ADDENDUM NO.: ONE (Rio Vista Elementary)

PROJECT: BID #1940 Modernization of Three Elementary School Campuses, Phase 1

ADDENDUM NO. 1

Project:	Mt Diablo Unified School District **Rio Vista Elementary School** **Increment 1**	
19six #:	23118	
DSA #:	01-121440	File #:7-29
Bid #:	###	
Date:	April 16, 2024

BLDG. 5 REFLECTED CEILING PLAN | 1/8" = 1'-0" | 1

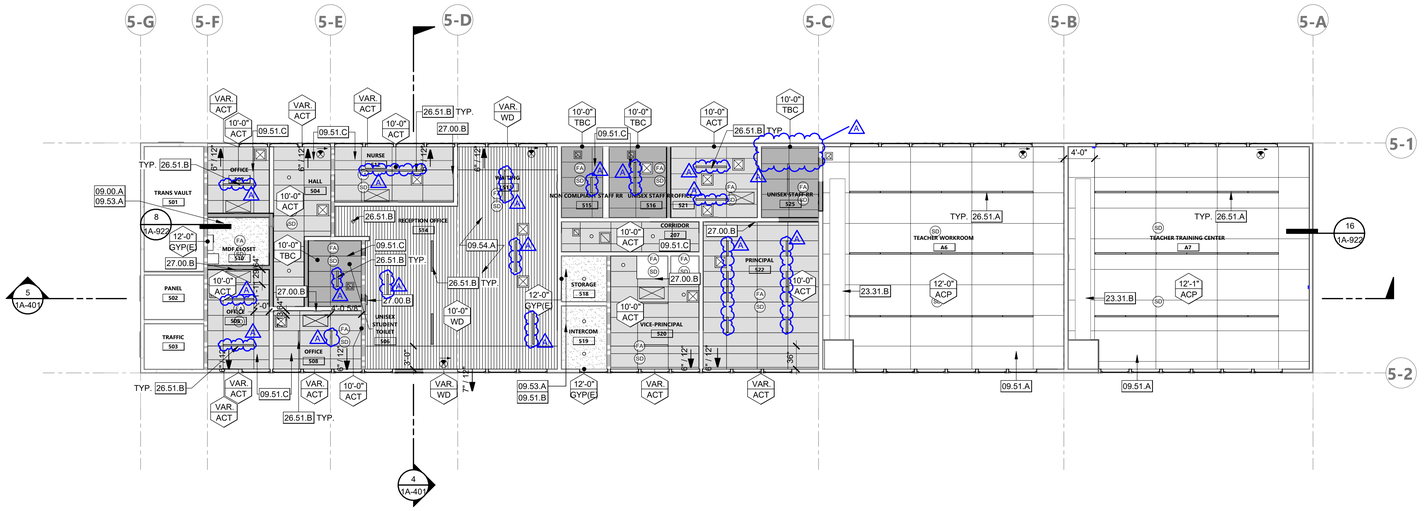
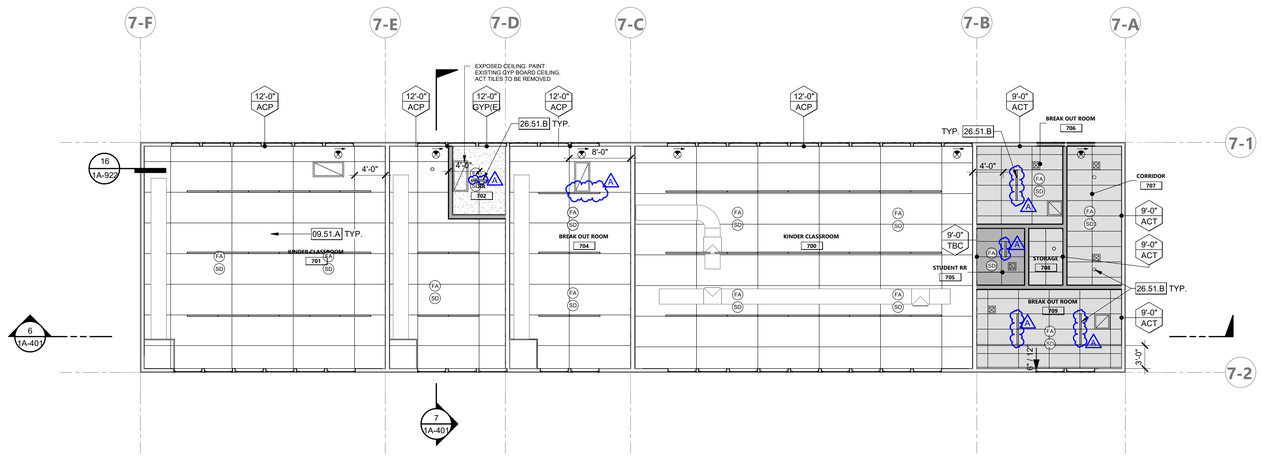
ITEM 19. 1A-212 - BLDG 5&7 -REFLECTED CEILING PLAN

- Ceiling Legend:
    - Added View References to Acoustic Tile Ceilings.
    - Reduced number of View References for Panelized Wood Ceiling.
    - Added View Reference for New Gyp. Board Ceiling.
    - Added View Reference for Hexagonal Acoustical Panels.
    - Removed Recessed Roller Shades.
- Building 5 RCP:
    - Added Linear Light Fixtures to nearly all rooms of Admin Offices.
    - Removed Window from Unisex Staff Restroom Room 525.
    - Ceiling In Unisex Staff Restroom Room 525 is no longer sloped.
- Building 7 RCP:
    - Added Linear Light Fixtures to Rooms 702, 704, 705, 706, and 709.

2 FOUNDATION PLAN BUILDING 2

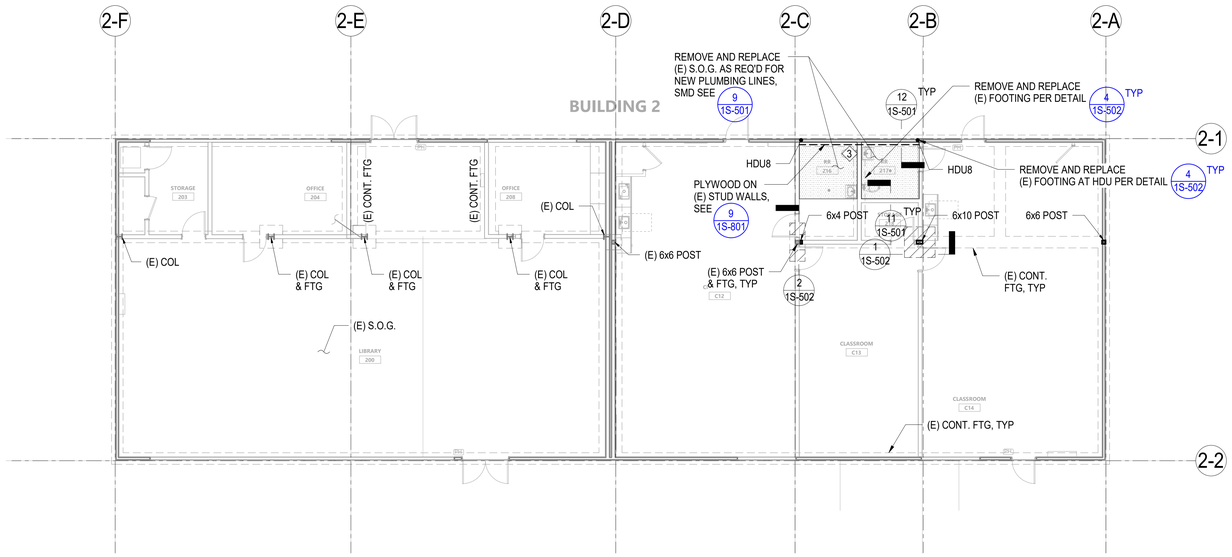
ITEM 41. 1S-201 - BUILDING 1 & 2 - FOUNDATION PLANS

- See updated (E) MEZZANINE DEMO PLAN BUILDING 2

2 ROOF FRAMING PLAN BUILDING 2

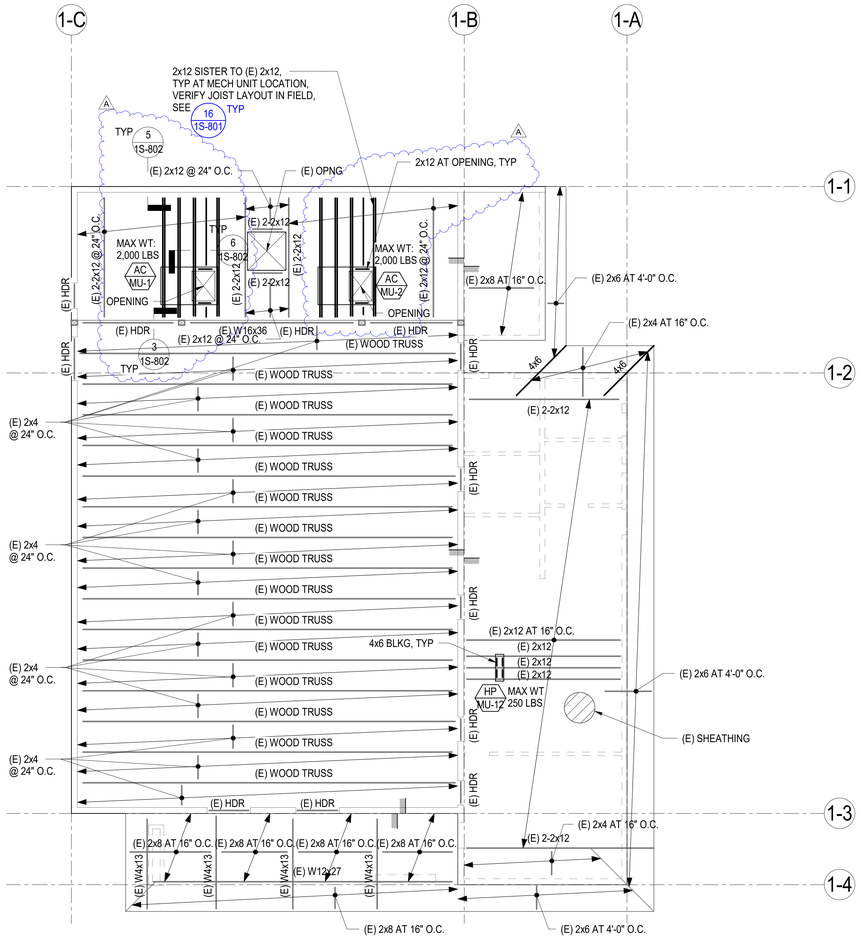
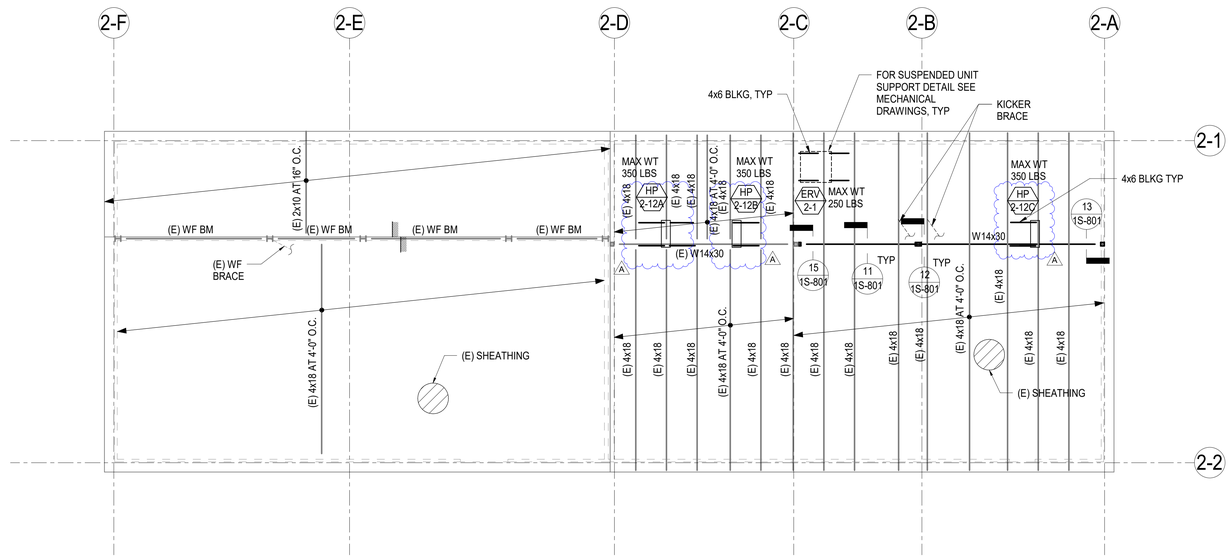
ITEM 42. 1S-203 - BUILDING 1 & 2 - ROOF FRAMING PLANS

- See revised 1S-203

2 ROOF FRAMING PLAN - BUILDING 7

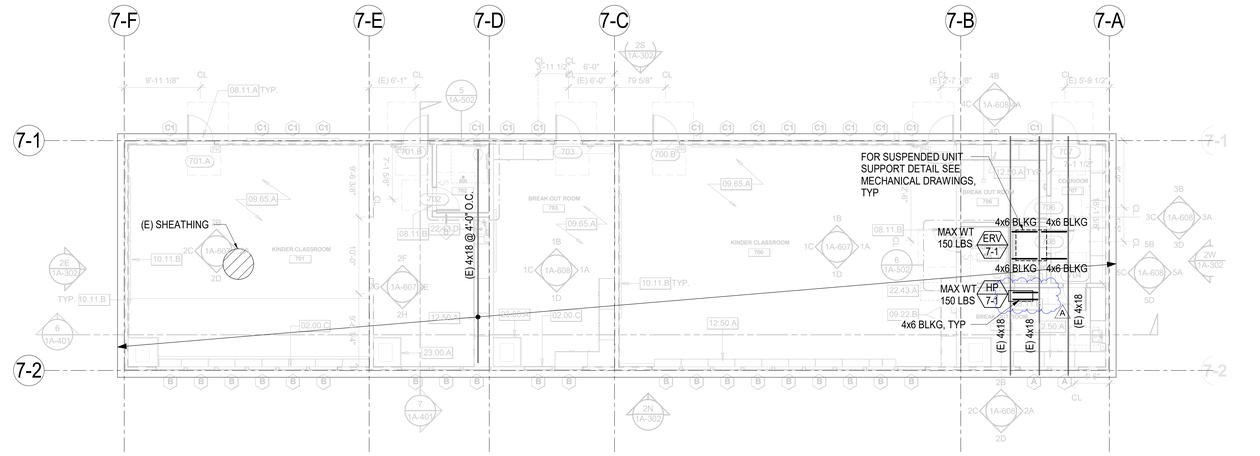
ITEM 43. 1S-204 - BUILDING 5 & 7 FRAMING PLANS

- See updated ROOF FRAMING PLAN - BUILDING 7

1 BLDG 2 - LIGHTING PLAN

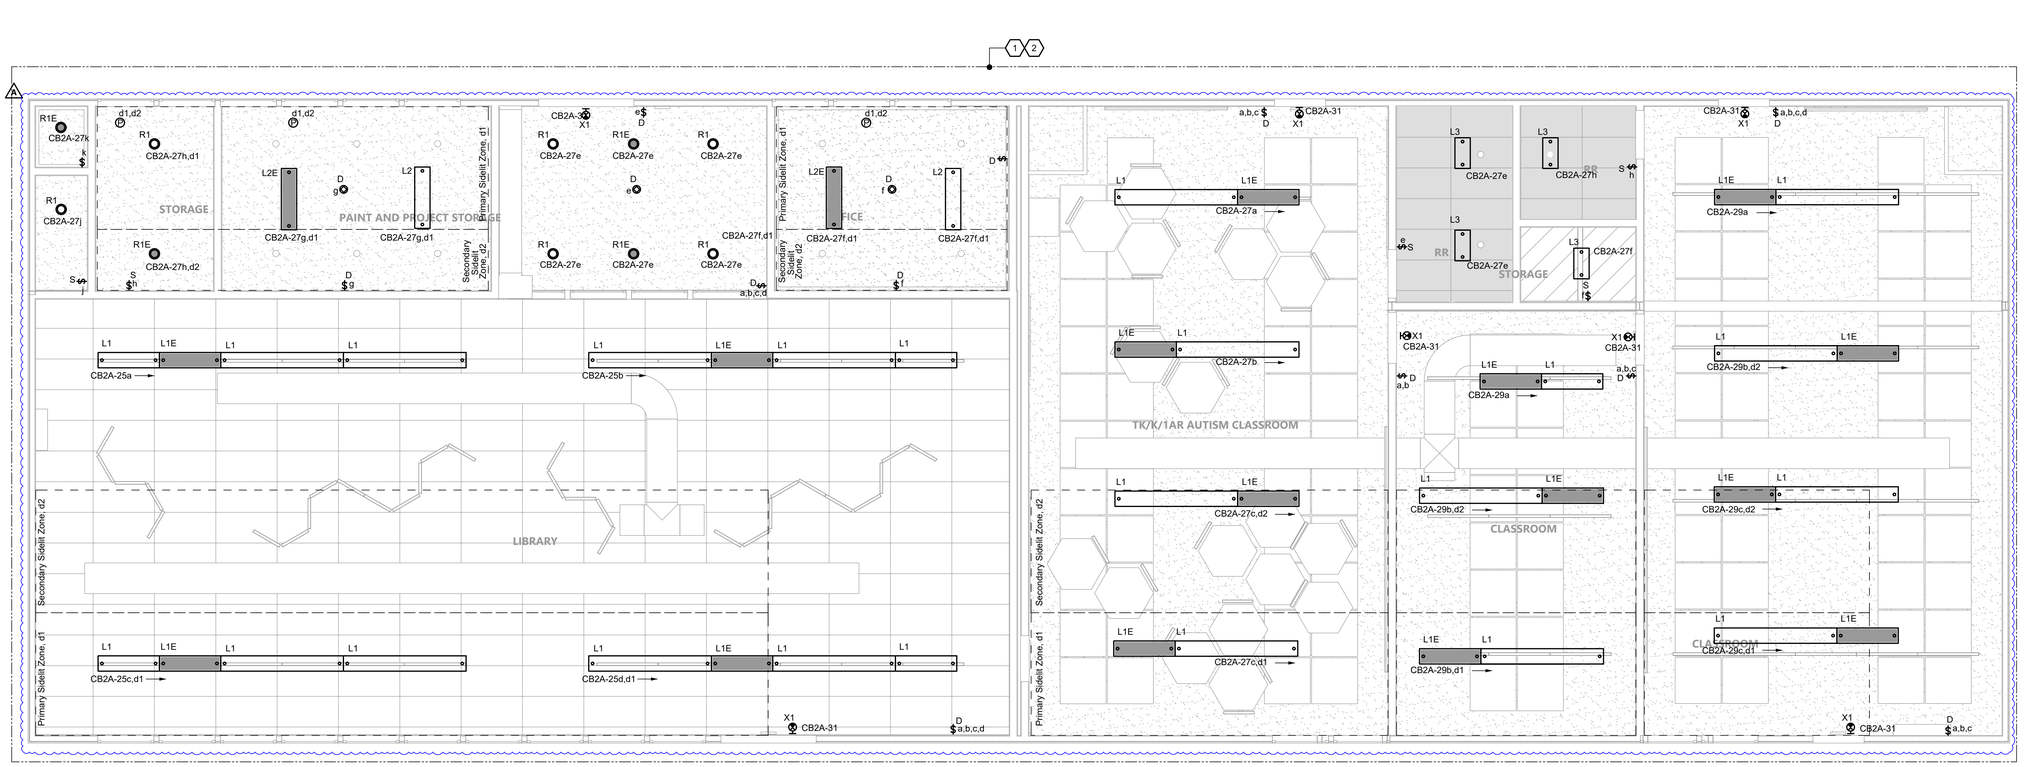
ITEM 50. 1E201 LIGHTING PLANS

- Text change to GENERAL DEMOLITION NOTES
- See updated BLDG 2 – LIGHTING PLAN

1 **BLDG 5 - LIGHTING PLAN**
1/4" = 1'-0"

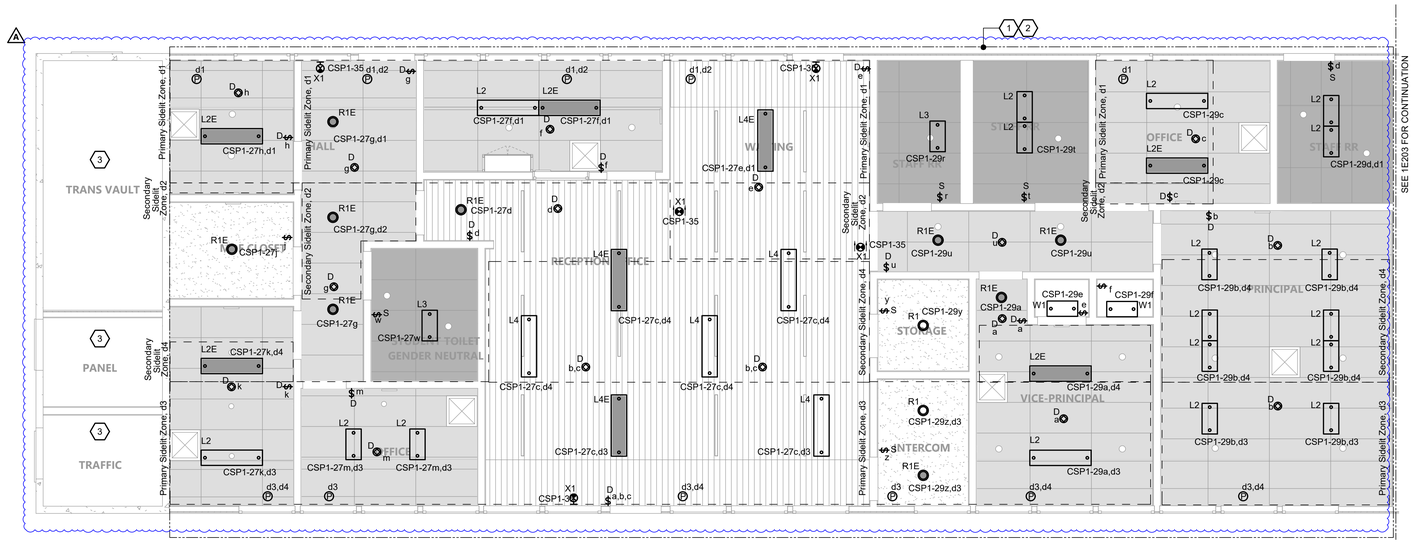
ITEM 51. 1E202 LIGHTING PLANS

- Text change to GENERAL DEMOLITION NOTES
- See updated BLDG 5 – LIGHTING PLAN
